Subject: **Tire Pressure Monitor Wiring Harness May Contact
Parking Brake Cable Compensation Spring**

Number: **03-01**

Model(s): **Touareg**

Date: **June 27, 2003**

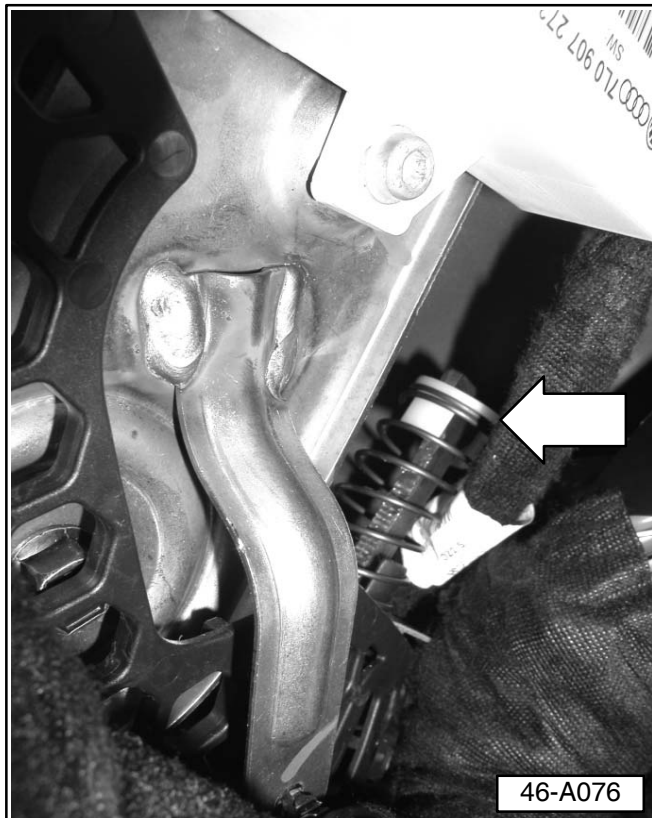
◀ Wiring Harness may contact parking brake cable spring (arrow).

◀ Illustration shows wiring harness contact with parking brake cable spring (arrow).

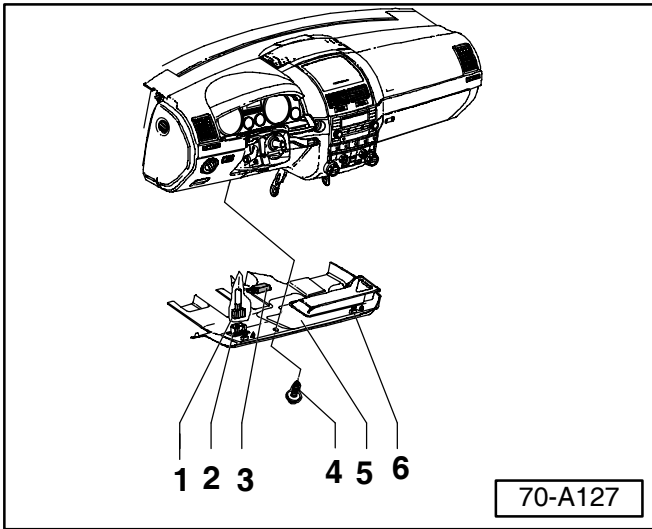
- Switch ignition OFF.
- Remove bolt -4- (2x).
- ◀ - Pry driver side footwell cover -5- out of mountings near clip -6- using wedge T10039/1.
- Pull cover out of rear mountings.
- Disconnect footwell light -3- from wiring harness.
- Separate wiring harness -1- from diagnosis plug -2-.
- Inspect wiring harness routing for tire pressure monitoring control module (black arrow).
- ◆ Harness must be routed behind and to the right of the main harness as shown in illustration 46-A077.

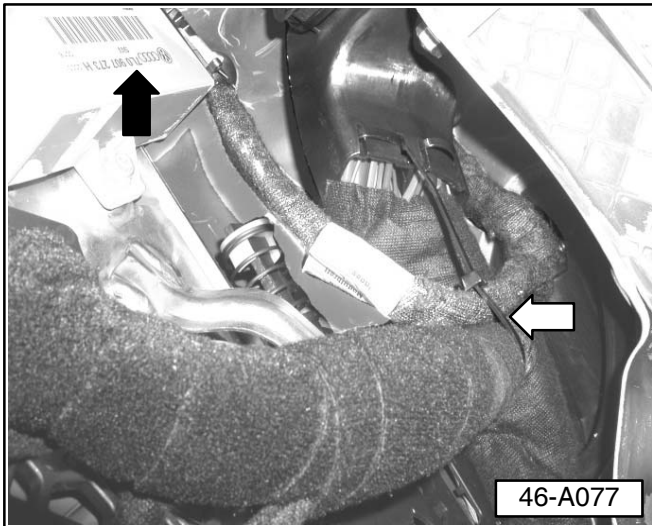
If wiring harness is not properly routed:

- Disconnect connector from tire pressure monitoring control module located on driver side lower A-pillar (black arrow).
- ◀ - Route harness behind and to the right of the main harness as shown.
- Reconnect connector to tire pressure monitoring control module.
- Tie-wrap harness to main harness as shown (white arrow).
- Install driver side footwell cover in reverse order of removal.
